**COLOGNE CITY COUNCIL  
RESOLUTION NO. 13- 13**

**A RESOLUTION APPROVING A FINAL PLAT OF 13 RESIDENTIAL  
SINGLE FAMILY LOTS ON 3.889 ACRES FOR  
HANS HAGEN HOMES**

Re: Village at Cologne 15<sup>th</sup> Addition Final Plat  
Amended Memo

**RE: The Village at Cologne Fifteenth Addition  
Plat Review**

# THE VILLAGE AT COLOGNE FIFTEENTH ADDITION

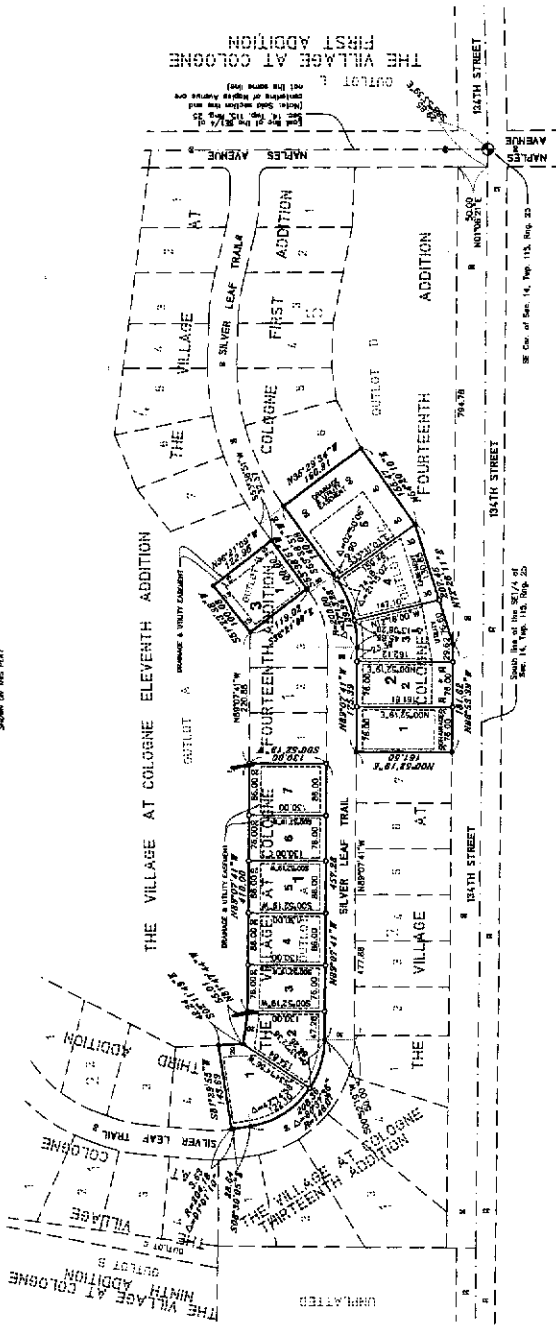
- 5) The Drainage and Utility Easements (D/U's) shown appear to conform with previously submitted plats and construction plans, however, we recommend the following be considered:

- a. All D/U's should extend an adequate distance upslope from ponds and drainage swales top of slope to allow access for maintenance equipment.
  - b. We recommend a minimum of 10 feet of easement width be provided upslope of pond and swale top of slope for maintenance access, such that the access area is located on slopes flatter than 4:1.

- c. The above recommendations may require some adjustments in D/U widths based on the existing as-built grading of the site.
